**Water Right Conditions  
Tracking Slip**

FILE ## G-17536

**PUBLIC INTEREST REVIEW FOR GROUND WATER APPLICATIONS**

# Application G-17536, Homer and Jeannette Harrison

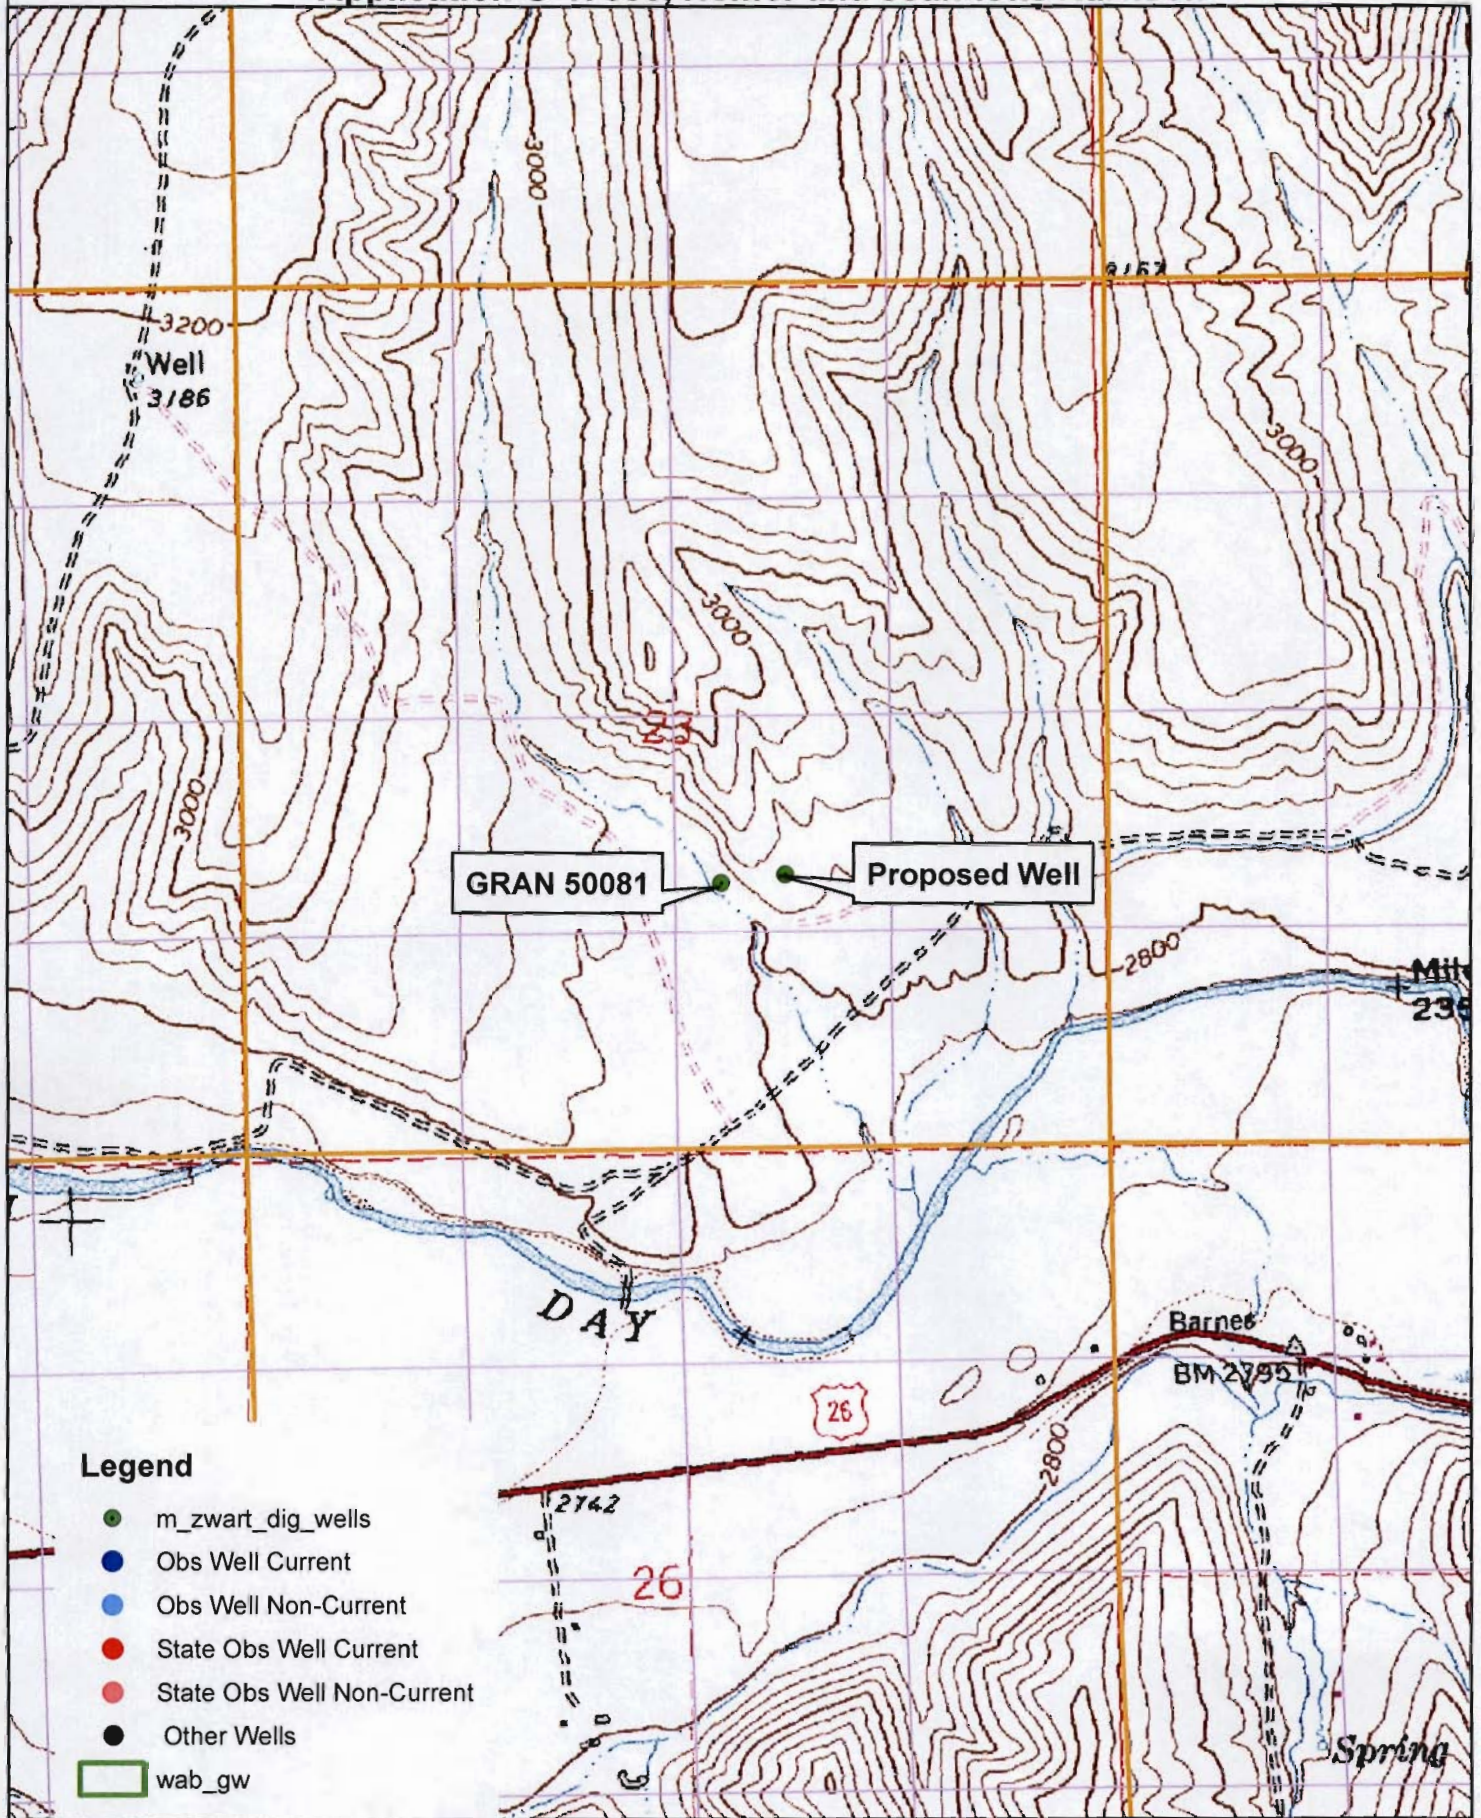
**Basis for aquifer confinement evaluation:** The proposed well may need to be deeper than 300 feet to penetrate below the Rattlesnake Formation. Local wells that develop these aquifers all appear to have water levels above the level where groundwater was first encountered.

**Basis for aquifer hydraulic connection evaluation:** The aquifer developed by well #1 could be in indirect hydraulic connection with the alluvium within the John Day River valley, given the head relationship. However, the complex local geology makes a positive finding of hydraulic connection problematic.
